## Volvo Chassis - Model VN, Hood Release Cable Interference

### Internal Content

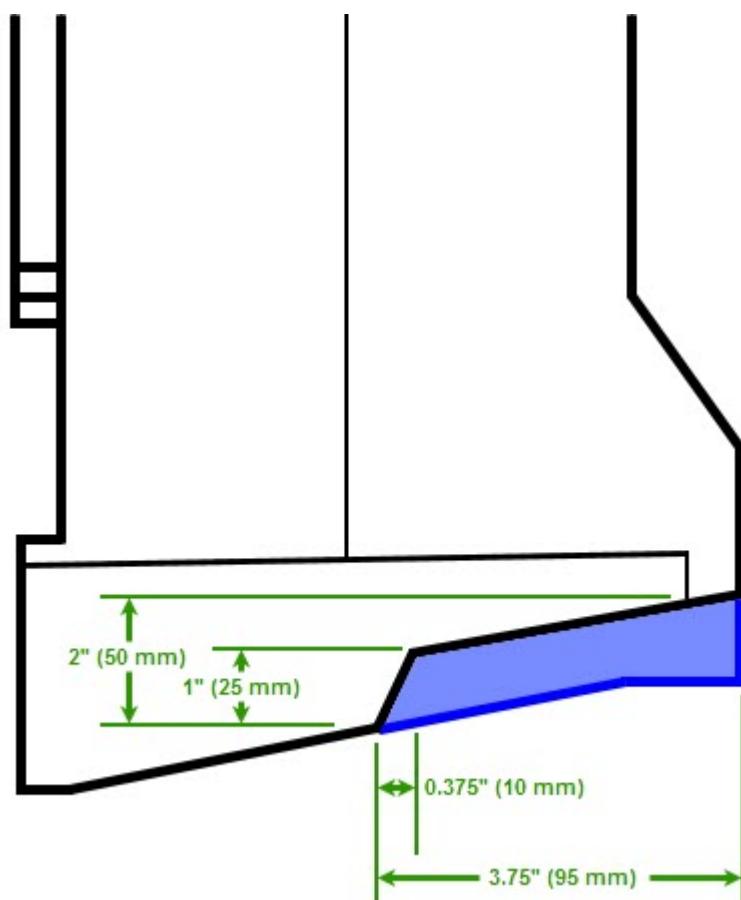
For vehicles affected by this issue, the corner of the air box will need to be modified:

Using an appropriate tool, cut the corner off of the air box. This will allow the cable to straighten out and prevent fatigue. A diagram with approximate dimensions can be found below. The blue section is the portion that will be trimmed off:
